Attachment 1 - PLN21/0670 - 223 - 229 Johnston Street & 369 Gore Street Fitzroy - Site Location Plan

Urban Design Memo

To:	Julian Larkins	Date:	31.01.2022
Company:	City of Yarra	From:	Hansen Urban Design Team
Re:	223-229 Johnston Street & 369 Gore Street, Fitzroy

Attachment 2 - PLN21/0670 - All referral comments

Cross section – The Proposal at Argyle Street, indicative 45 degree sight line measure illustrated

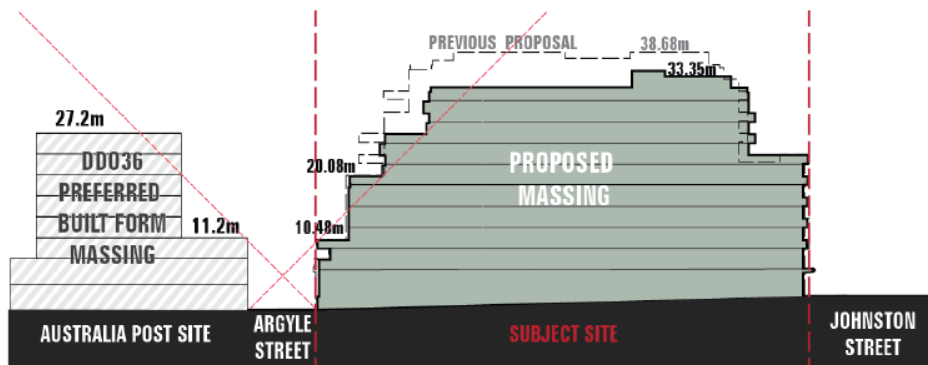
- The proposed envelope (overall scale and street wall height) now broadly accords with the discretionary 9 storey or 30.4m preferred height limit. With a maximum height of approximately 33.35m (above Johnston St) the proposal is slightly above the DDO’s discretionary height limit (of 30.4m), however we find this to be supportable given the corner location, surrounding built form conditions and broad compliance with other measurable parameters outlined in DDO36 and DDO10. It should also be noted that the top storey is visually recessive. Further, the proposal also accords with the VCAT direction which was to remove Level 9 or 1 storey.

- The reduction in height by 1 storey is supported and assists in ensuring that the proposal acknowledges and transitions down to and towards the former MacRobertson heritage complex. This was a necessary refinement in order to respect the low-rise nature and avoid visually dominating buildings, again as sought by the DDO10. As seen in the figure below, further erosion to the north-east corner in the form of increased upper level setbacks now gently transitions to the former confectionary factory fabric. It also now ensures that any built form above a 6 storey profile is now invisible from standing eye height on the northern side of Argyle Street directly opposite the proposal. Additionally, it does well when assessed against overshadowing criteria only marginally impacting the Johnston Street footpath at 10am on 22nd September.

Extract of Gore Street elevation, illustrating massing and overall height profile in comparison to VCAT application plans.

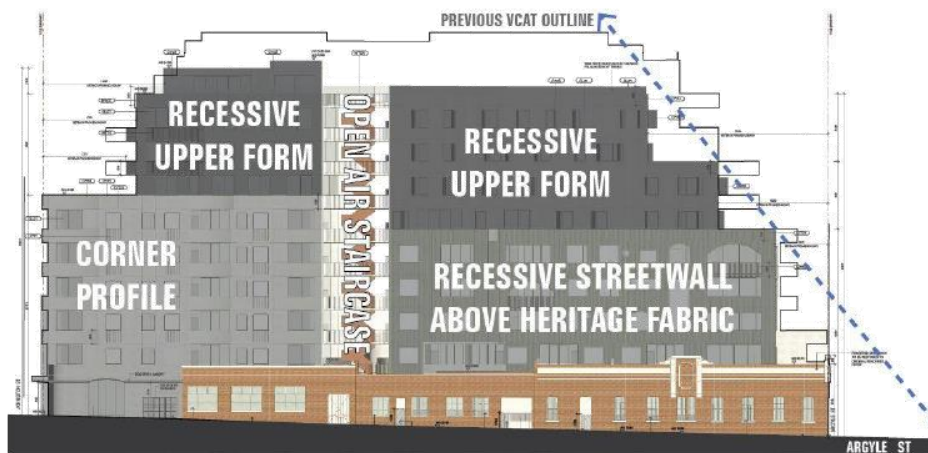
- We are supportive of the increased setback of the upper level above the heritage from Argyle Street, we believe this successfully and respectfully integrates the proposal into the existing heritage fabric while responding to the direction of VCAT. The Argyle Street setback requirement of 10m outlined DDO36 is primarily sought to ensure that the narrower profile of Argyle Street is respected and to ensure there is not a strong sense of visual enclosure as the larger sites to the south fronting Johnston Street develop. The increased setback in combination with the removal of the projecting balconies results in an appropriate building elevation with a massing and presence that is now more respectful of the retained heritage fabric and narrower Argyle Street profile. It should also be noted that the proposal retains more of the heritage street wall than specified in DDO36. We consider this a positive and appropriate gesture.

Extract of SD02_10, showing smoke lobby in east-west corridor

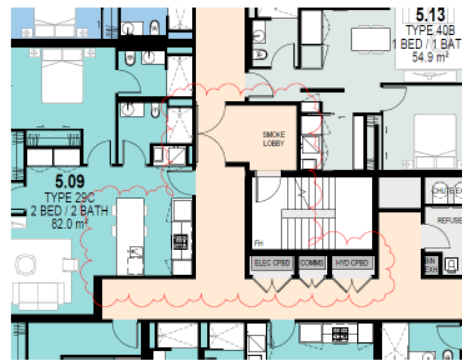
- While we understand the smoke room is a functional requirement of the proposal its current door arrangement is unfortunate with nib walls that project into the corridor space from Level 1 to Level 6, diminishing site lines along the corridor. Resolving this will not only be an aesthetic improvement but will ensure improved circulation and functionality throughout the building. Therefore, **we recommend reconsideration or an alternative door solution that ensure the corridor remains as wide and uncluttered as possible.**

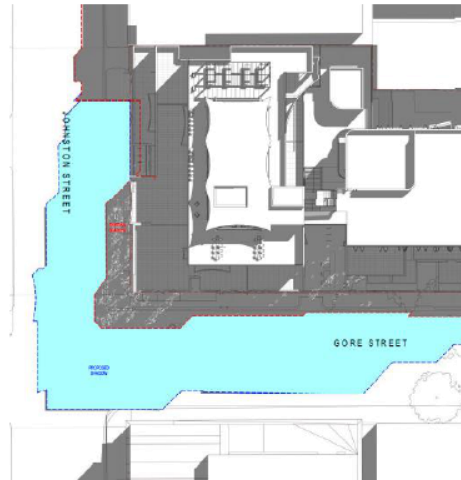
- The proposal meets the requirements of DDO36 in relation to equitable development which requires a setback minimum of 4.5m from the common side boundary, where a habitable window or balcony is proposed and/ or exists.

Figure 1: balcony encroaching onto the footpath of Johnston Street

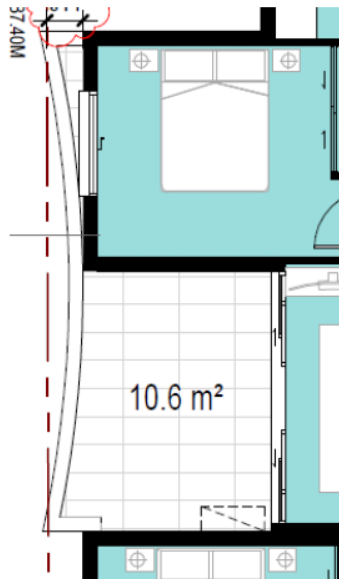
The balconies are also projecting onto the street boundary (Johnston Street and Gore Street) as shown on the figure 1 and figure 2 below:

Figure 3: overshadowing at 10am (overshadows southern footpath on Johnston Street)

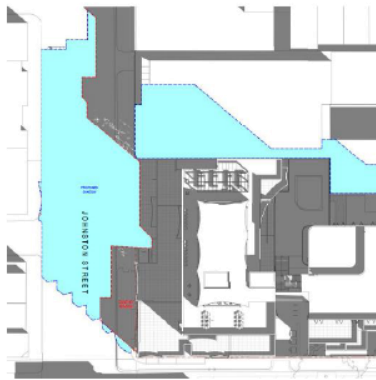
The development does not comply with the requirements of the DDO36 as it shadows the southern footpath on Johnston Street at 10am (figure 3) and eastern footpath on Gore Street at 2pm (figure 4).

The proposal needs to be revised to comply with the overshadowing requirements in DDO36.
